ADDENDUM NO. 3 TO PROJECT NO. 45410

**CONSTRUCTION, HVAC, PLUMBING AND ELECTRICAL WORK
PROVIDE CLASSROOMS & CELL ALTERATIONS
S-BLOCK – BUILDING NO. 29
LAKEVIEW CORRECTIONAL FACILITY
LAKE AVENUE
BROCTON, NEW YORK**

June 26, 2017

DRAWING NUMBER: **M-100**

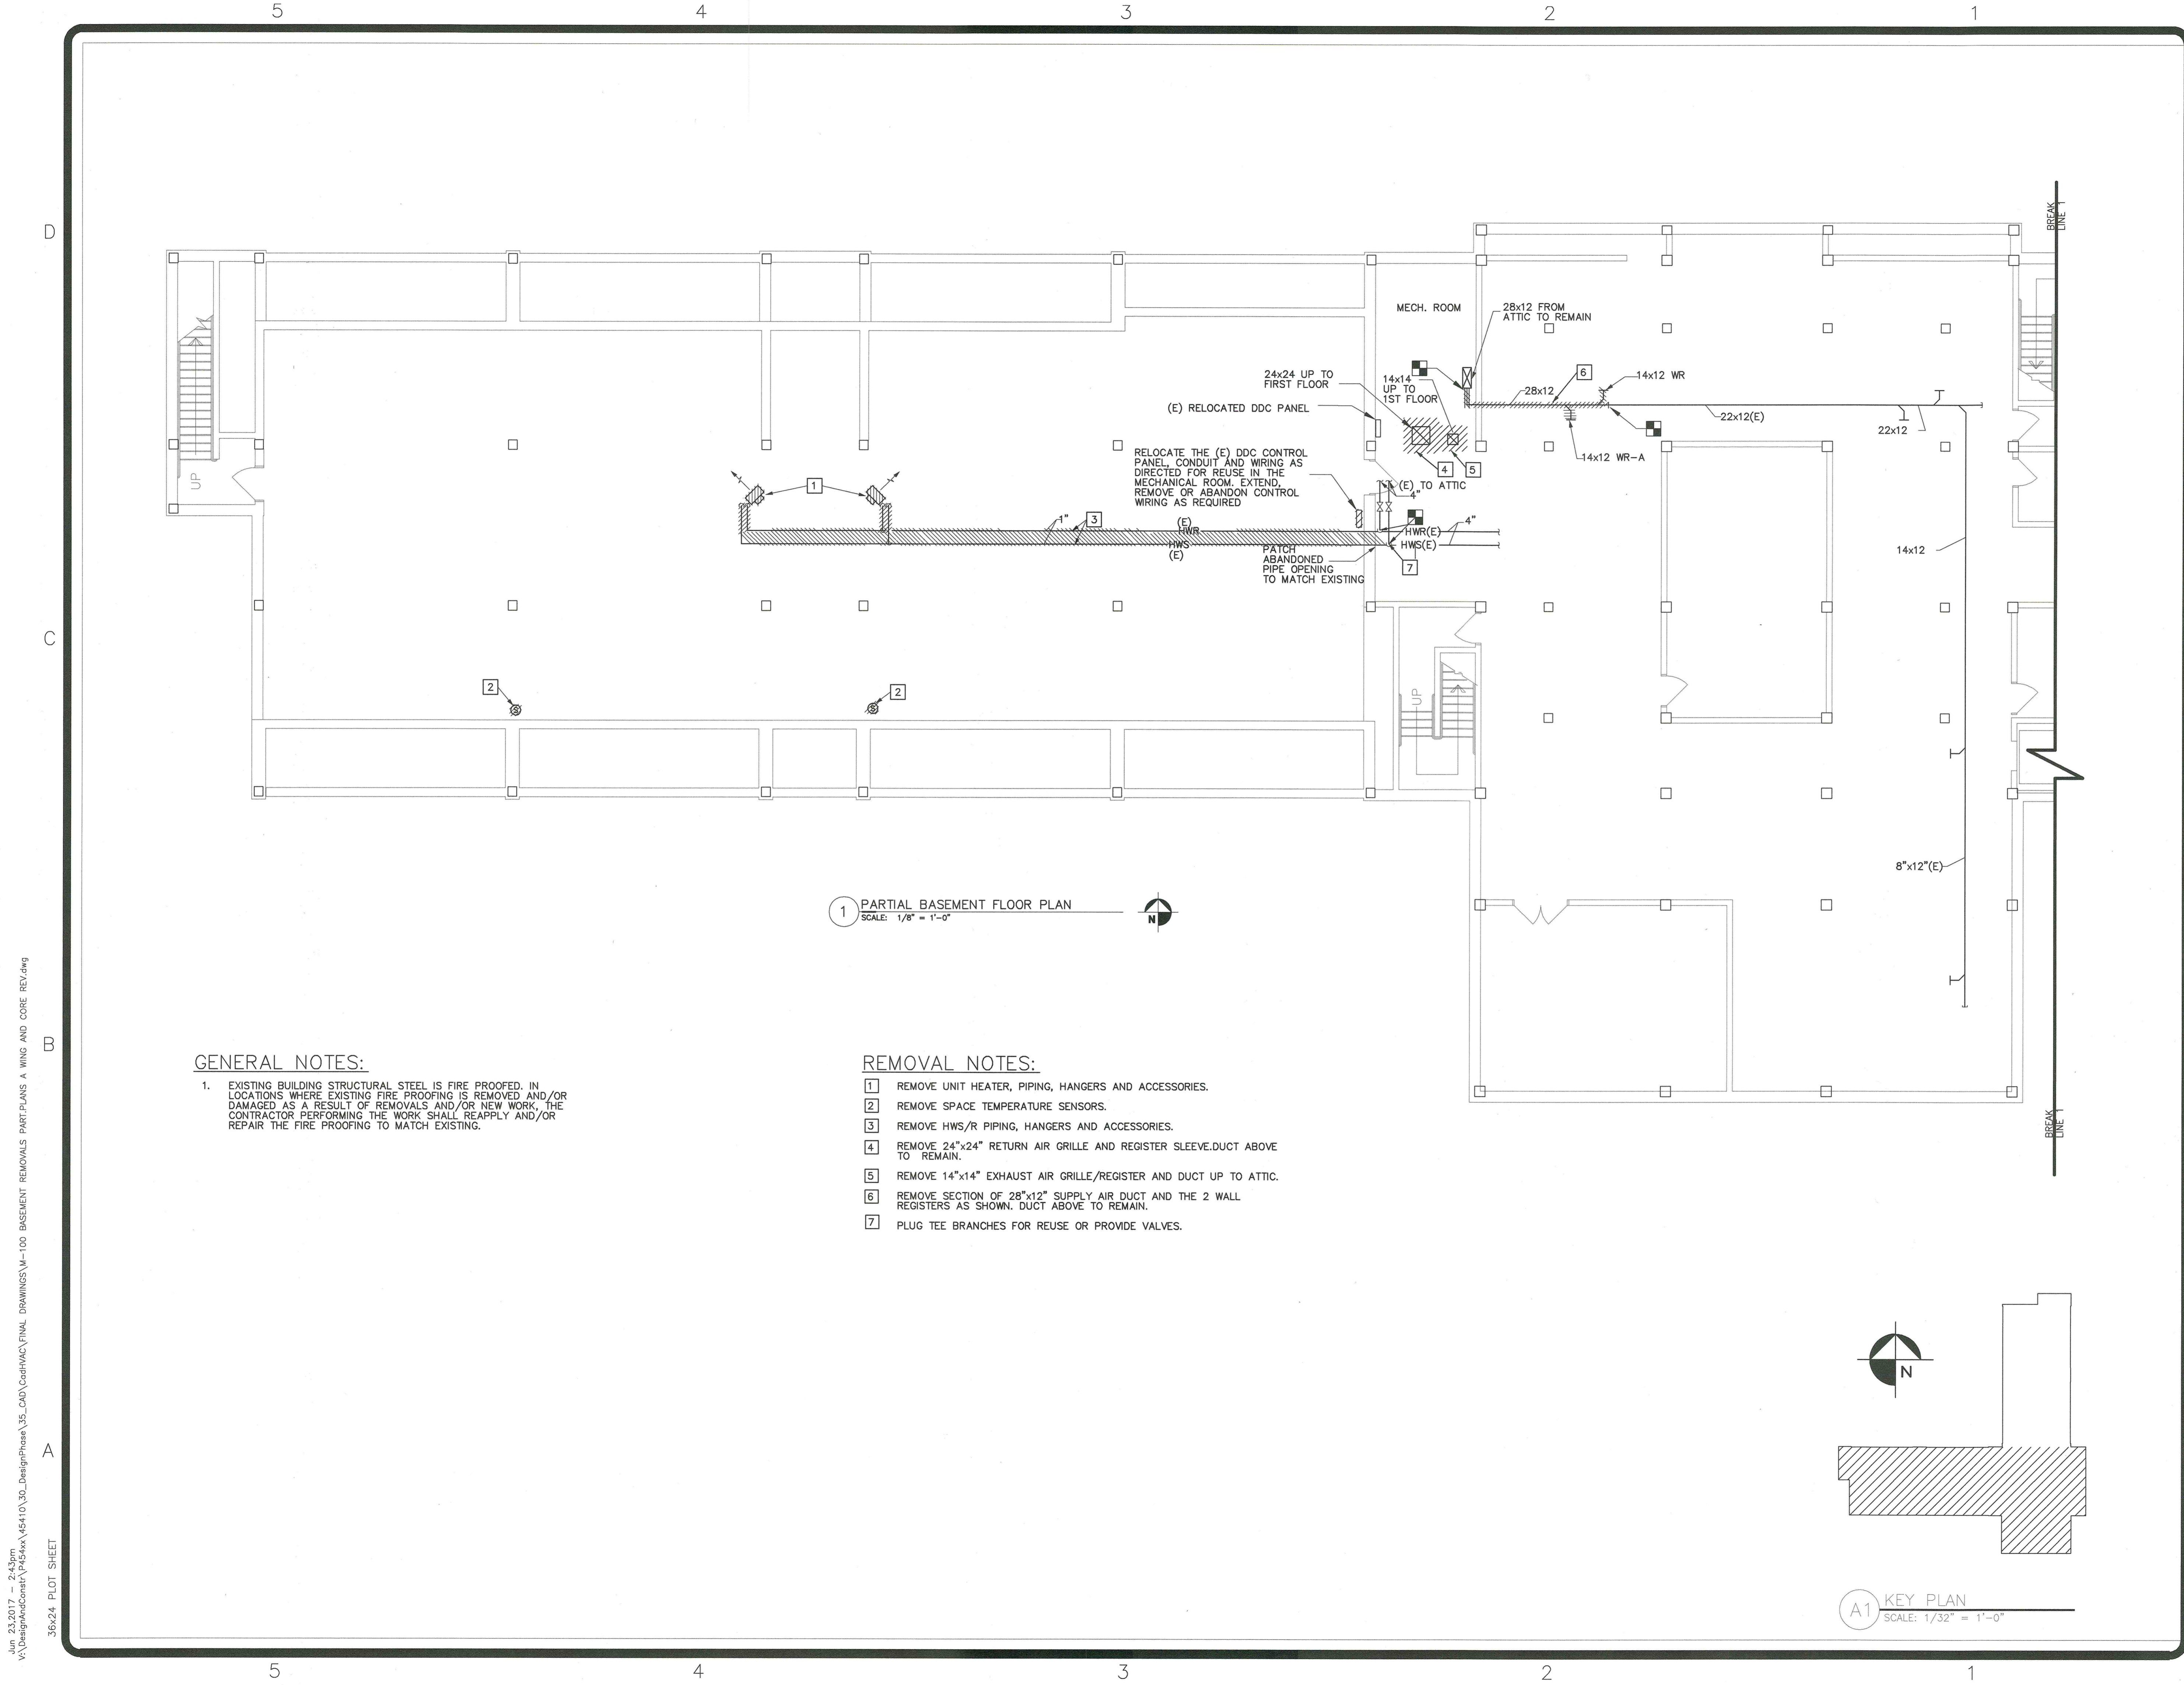
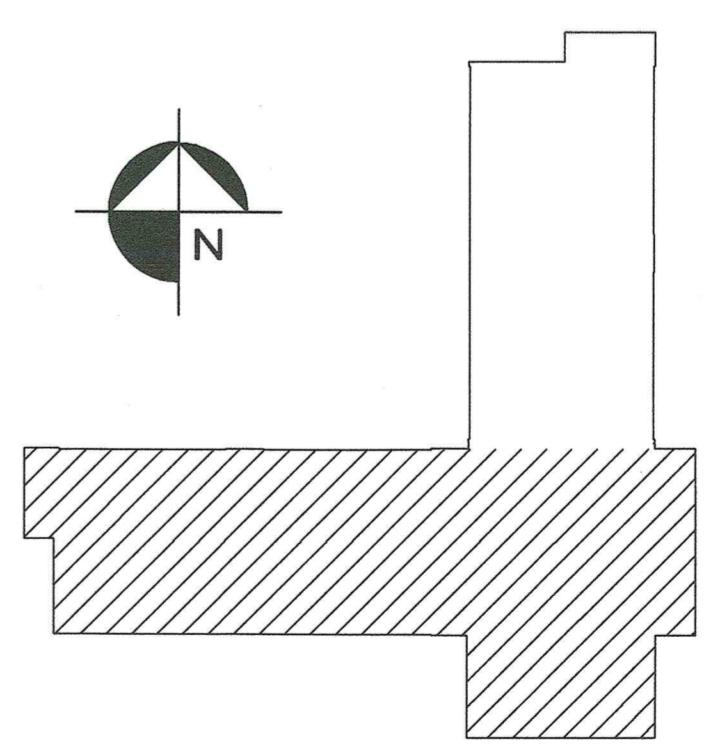
12. Revised Drawing:
 - a. Drawing M-100, noted “ADDENDUM NO. 3” and dated, “6/23/17” accompanies this Addendum and supersedes the same numbered originally issued drawing and forms part of the Contract Documents.
13. Revised Drawing:
 - a. Drawing M-102, noted “ADDENDUM NO. 3” and dated, “6/23/17” accompanies this Addendum and supersedes the same numbered originally issued drawing and forms part of the Contract Documents.
14. Drawing No. M-001, HVAC GENERAL NOTES:
 - a. Change General Note 12 to read:
